Project	IEEE 802.16 Broadband Wireless Access Working Group < http://ieee802.org/16 >	
Title	Frame Structures for 7MHz and 8.75MHz Channel Bandwidths	
Date Submitted	2009-01-07	
Source(s)	Jaeweon Cho, Hoky Choi, Heewon Kang, Jeongho Park, Hwasun Yoo, Jaehee Cho Samsung Electronics Co., Ltd.	Voice: +82-31-279-5796 E-mail: jaeweon.cho@samsung.com
Re:	IEEE 802.16m-08/053r1, "Call for Comments and Contributions on Project 802.16m Amendment Working Document".	
	<ul style="list-style-type: none"> Target topic: Call for Comment on Amendment Working Document Text (IEEE 802.16m-08/050). 	
Abstract	This contribution proposes frame structures for 7MHz and 8.75MHz channel bandwidths.	
Purpose	To be discussed and adopted by TGM for the 802.16m Amendment Working Document.	
Notice	<i>This document does not represent the agreed views of the IEEE 802.16 Working Group or any of its subgroups. It represents only the views of the participants listed in the "Source(s)" field above. It is offered as a basis for discussion. It is not binding on the contributor(s), who reserve(s) the right to add, amend or withdraw material contained herein.</i>

Frame Structures for 7MHz and 8.75Mhz Channel Bandwidths

[Figure xxx Frame Structure with type-1 and type-3 subframes in TDD duplex mode for 7 MHz channel bandwidths \(CP=1/8 \$T_b\$ \)](#)

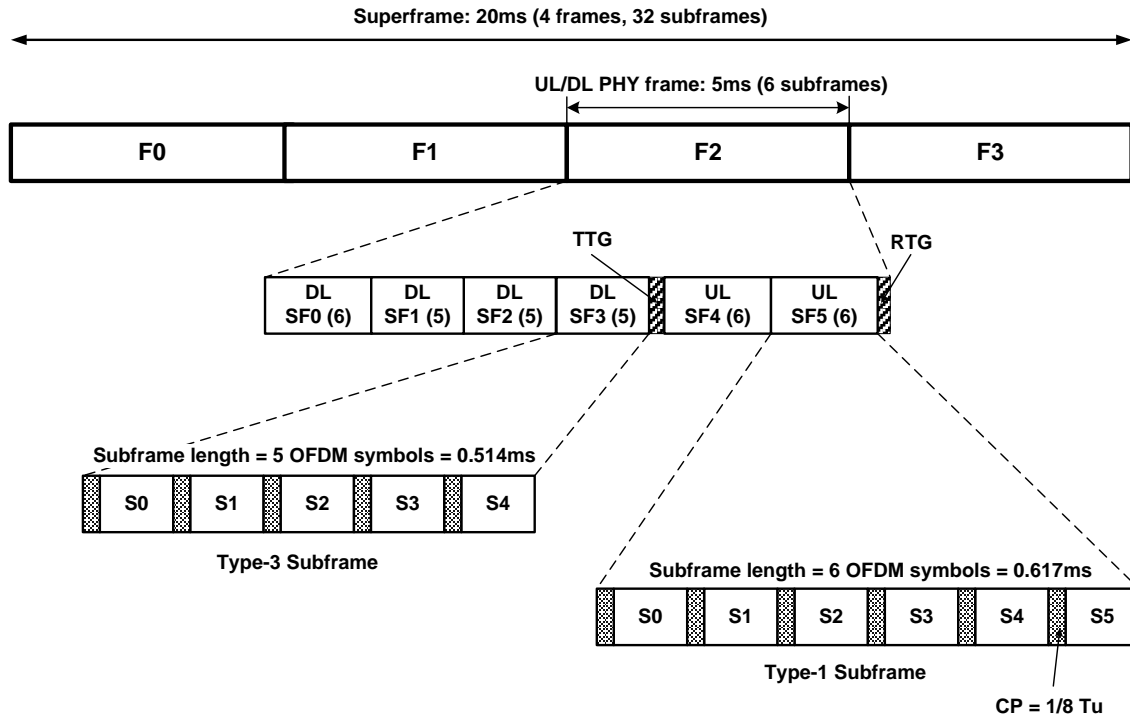
[Remedy 2: Insert the following text and Figure after Figure 391 in page 17]

Figure xxx illustrates an example TDD frame structure with D:U = 4:2, which is applicable to the nominal channel bandwidth of 7MHz with $G = 1/8$.
